PC Agenda: 1/28/15 Item: 4.b.

Subject: Public Comments on Draft Initial Study and MND for Primrose Preschool (CP14-039)

SUBJECT: A Conditional Use Permit to allow the operation of a 2-story, 12,715 square feet

**Location:** 1500 Hamilton Avenue (APN 429-46-056 and 429-41-040).

WG Earthquake Fault runs from WillowMeridian to AlmExFoxworthy.png;

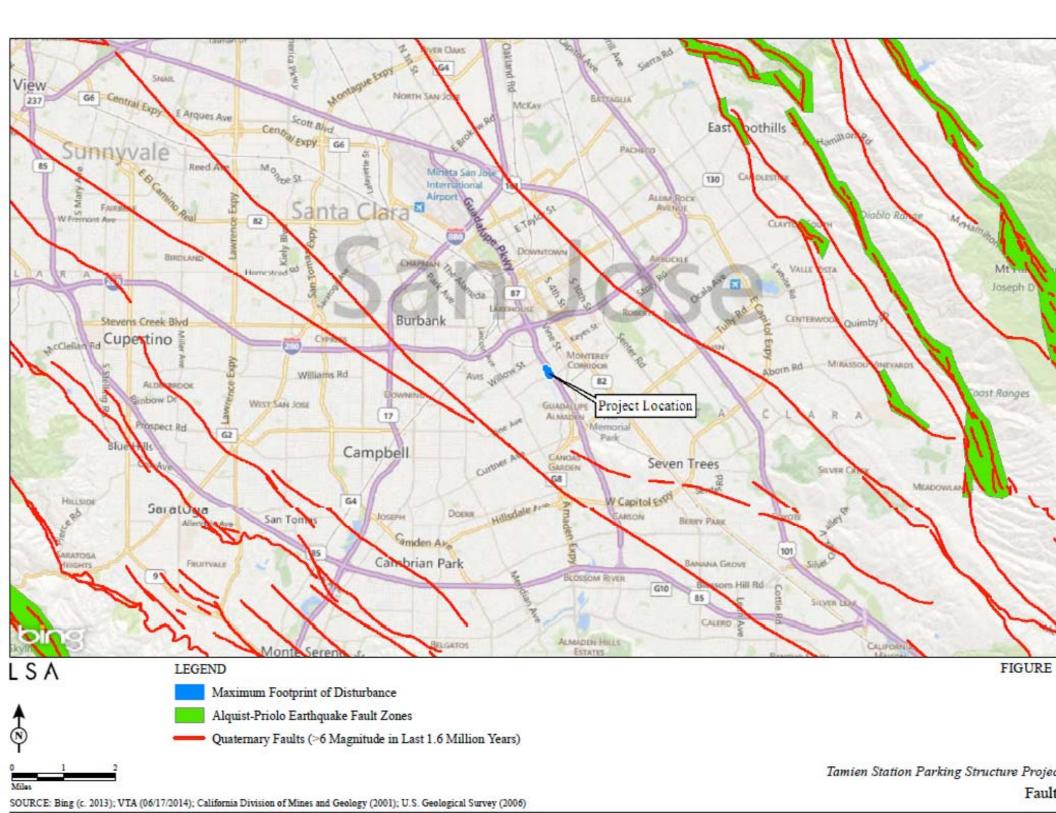
I noticed the MND didn't mention Quaternary Faults in Earthquake hazards. Does San Jose ignore Quaternary Faults. VTA's MND for the Tamien Parking garage included a discussion and a map. Their map shows a Quaternary Fault going through the Primrise Preschool project. Is there any concern about this since it is a site for children? Does it change construction requirements? Does it change what is allowed?

See attached map.

Response: Quaternary fault is a term for a currently dormant fault that has been inactive for more than 700,000 years. The City Geologist evaluates all faults that are potentially dangerous to a development, including quaternary faults. According to the California Geologic Survey's 2010 Fault Activity Map, the project site is not located on a fault, quaternary or otherwise. Due to its location in a seismically active region, the proposed preschool building and associated playground may be subject to strong seismic ground shaking during their design life in the event of a major earthquake on any of the region's active faults. This could pose a risk to proposed structures and infrastructure. Seismic impacts will be minimized by implementation of standard engineering and construction techniques in compliance with the requirements of the California and Uniform Building Codes for Seismic Zone 4. Therefore, there is a less than significant impact to the project from faults.

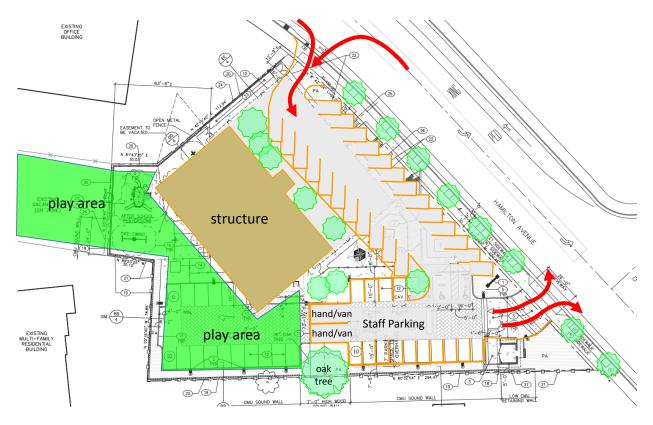
- Figure 4 in the IS/MND is inconsistent with Fig. 6: the former shows that a large, ordinance-sized oak tree along the property line is to be preserved, whereas the latter shows it removed. Since the document states on p. 22 that the "project site contains one coast live oak (Quercus agrifolia) that will be retained as part of the project" I assume that Fig. 6 is in error.

- The parking lot layout shown in the IS/MND Fig. 4 appears to be awkward: it is a single dead-end aisle that is meant to handle the several hundred drop-off and pick-up trips per day. (Page 55: "Since the proposed project is admitting students with ages ranging between infants and elementary school students, it is assumed that all parents would park on-site and walk their children to/from the proposed facility.") The traffic impact analysis in Appendix D notes that the "parking drive aisle width does not meet the City standards" and "[s]ome minor on-site vehicle queuing is to be expected due to a combination of the inherent unpredictability of vehicle arrivals at the driveway", but then it asserts that this is "unlikely to generate significant on-site circulation issues." However, my experience with crowded parking lots still has me worried: as shown in the diagram below, when one driver tries to park or leave, the car can block the aisle and preclude passage by others. When the parking aisle becomes congested, it is likely to back up traffic on Hamilton Avenue (which is only one-lane each way at that point), and I fear that a congested parking lot could easily congest this regional arterial roadway.

**Response:** The final plan set resolves the inconsistencies between figures in the IS/MND. No trees will be removed as a part of this project. Please refer to final site plans which are included in the revised Traffic Impact Analysis (TIA) and can be found on the City's Initial Study webpage at <a href="http://www.sanjoseca.gov/index.aspx?nid=2165">http://www.sanjoseca.gov/index.aspx?nid=2165</a>.
